Limited Visual Dam Safety Inspection Summary Report

MA-084

Reservoir 74

Dam ID: MA-0084
Name: Reservoir 74

084 View of the empty reservoir. Outlet works in lower right corner.

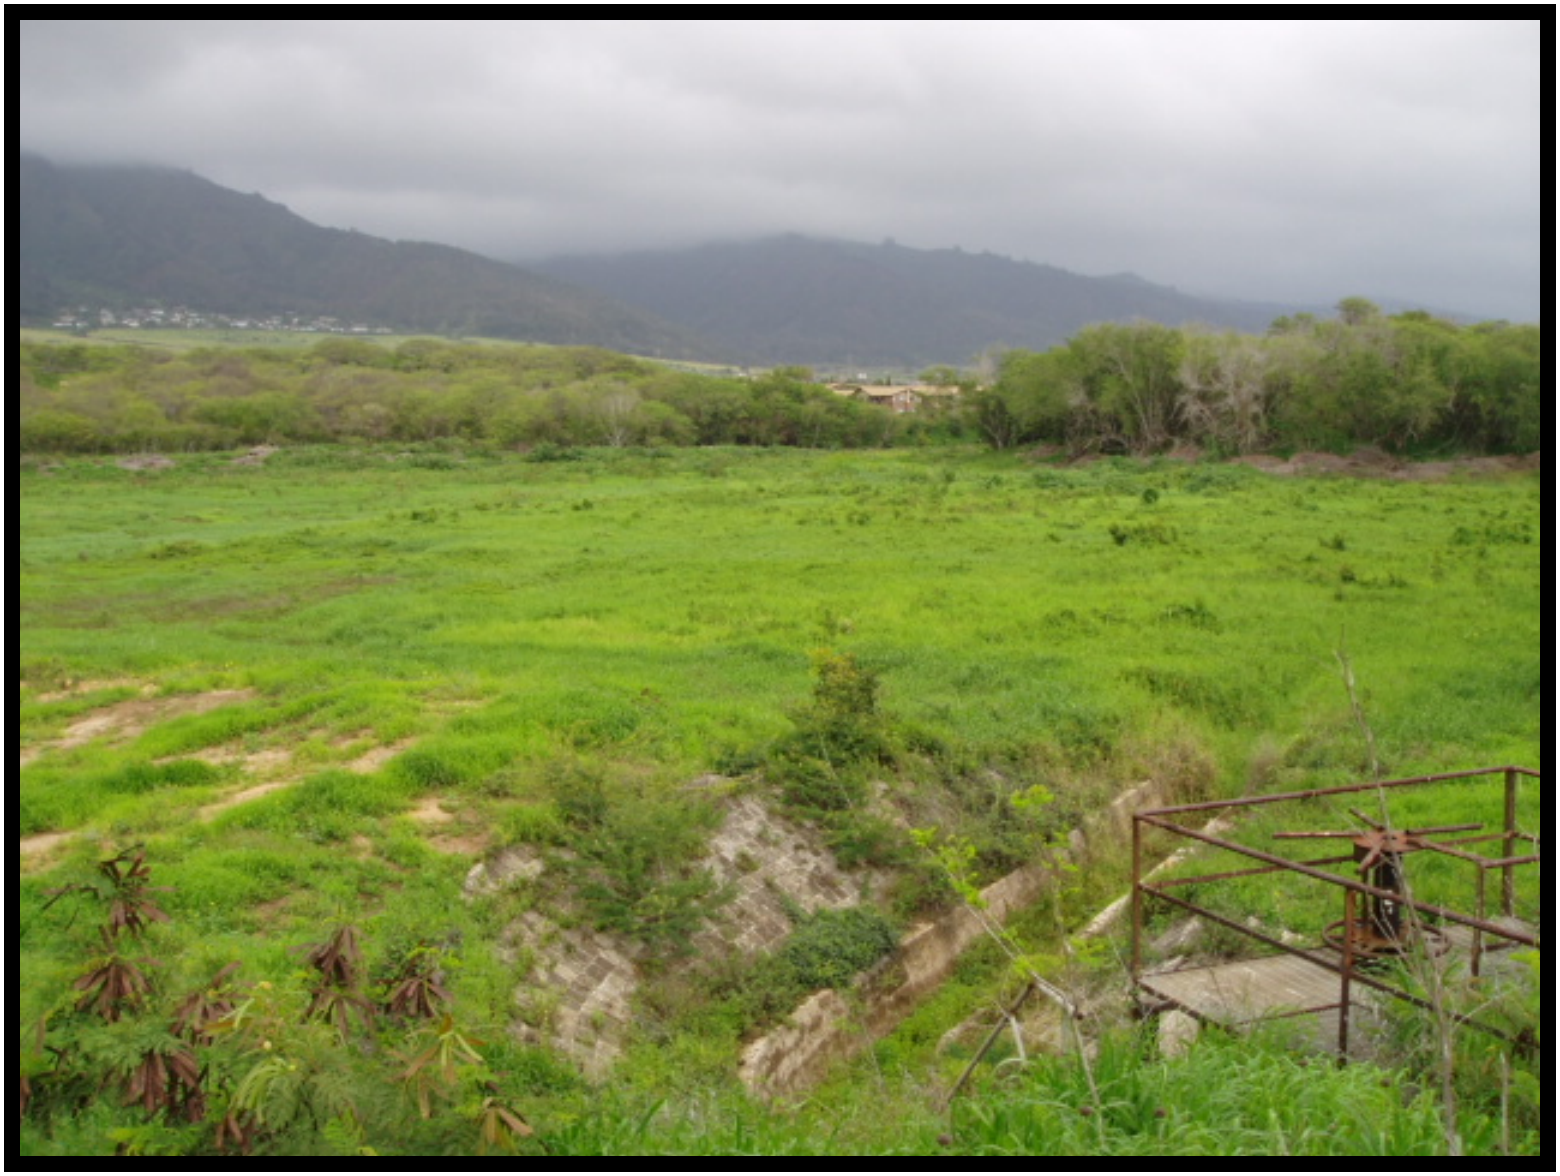
a. The reservoir was not inspected.

084 Upstream slope of the dam. Note tall grass on the slope.

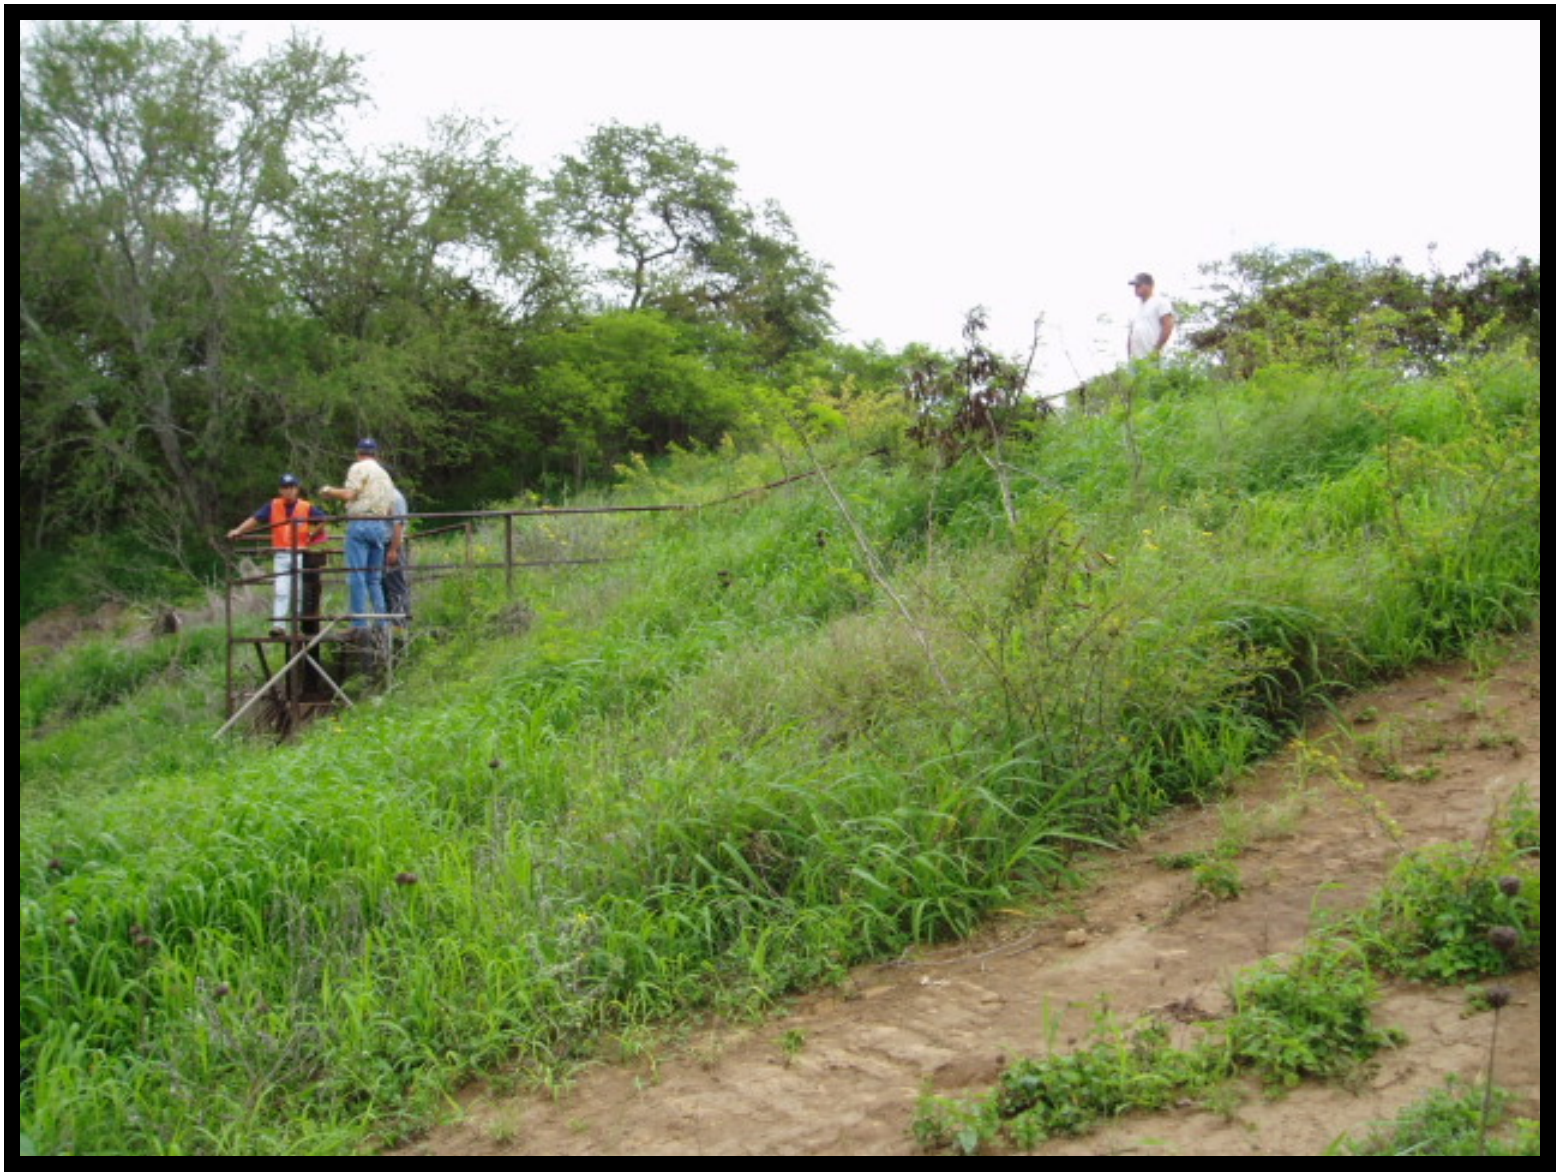
a. The upstream slope appeared to be in fair to poor condition and requires corrective action.
b. The upstream slope was not visible due to high grass and bush vegetation. Clear high vegetation and maintain low to enable easy visual inspection.

Long-term Recommendation:
1) The upstream and downstream slopes should be clear and visible for inspection. Underbrush and trees should be removed and grasses kept short. Large trees are growing on the slopes. Large trees and the stumps should be removed from the embankment.
2) The downstream slope of the dam is very steep (IV: 1 to 1.5H). Stability of the slope should be further evaluated.
